Official Transcript of Proceedings
NUCLEAR REGULATORY COMMISSION

Title: Advisory Committee on Reactor Safeguards

Date: Wednesday, September 6, 2023

8 Today, we're going to talk about Reg Guide
9 1.183 which, if you recall, we met on this quite a
10 while ago, back in 2022, I think, and maybe even in
11 2021. It's getting kind of long to remember the
12 history. But, given everything we have, the tight
13 schedule, and our audio difficulties, let's just get
14 into it and start with Mike Franovich to provide some
15 opening remarks.

DG-1389 Figure 1

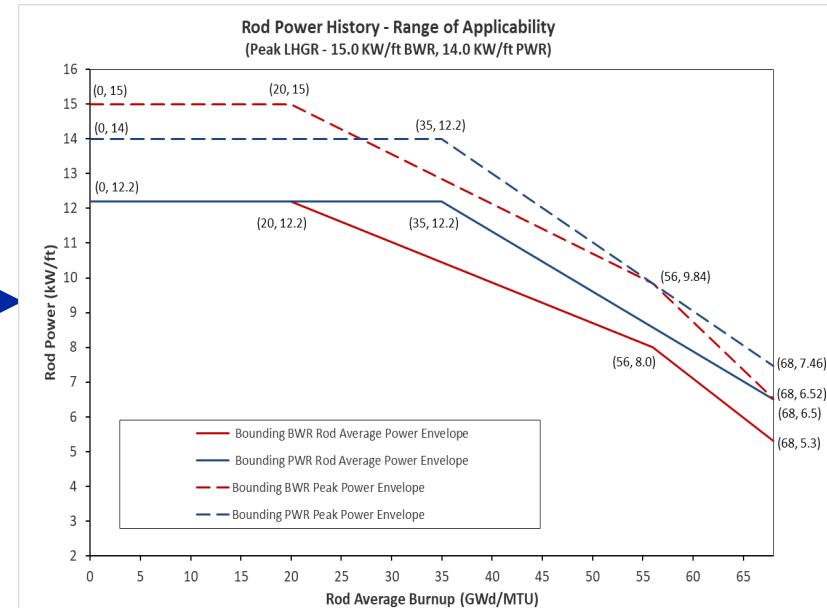
2 We received a few comments on the non-LOCA
3 gap fraction portions and Figure 1.

11 We were asked about the applicability of
12 the figure to partial length rods. Since we gave the
13 figure in terms of rod average power, partial length
14 rods at the bottom of a BWR likely would not be able
15 to meet the curve, even if at the same peak power
16 since they won't have the regions of lower power that
17 a full length rod would have.

- **Public Comments:** Staff received public comments related to Figure 1 regarding the treatment of power uncertainties, the peak LHGR, and the applicability of Figure 1 to part-length rods (PLRs)

18 So, we added the peak power curve to the
19 Figure 1. And that peak power curve can be met for
20 the partial length rods, then the gap fractions in the
21 tables can be used.

- **Response to public comments:**
 - Staff specified that power uncertainties should be accounted for when demonstrating adherence to the Fig. 1 power envelope, as stated in the Clifford tech. bases document referenced in DG-1389

- Staff stated that the peak LHGR is not meant to be exceeded. If it cannot be met, the licensee can follow the procedure outlined in Appendix I
 - Staff stated that the non-LOCA gap fractions can be applied to PLRs if they meet the peak LHGR curve that was added to Fig. 1

- **Changes made to DG-1389:** staff updated Figure 1 to include peak LHGR power envelopes and added clarification on treatment of PLRs and power uncertainties to RP 3.2
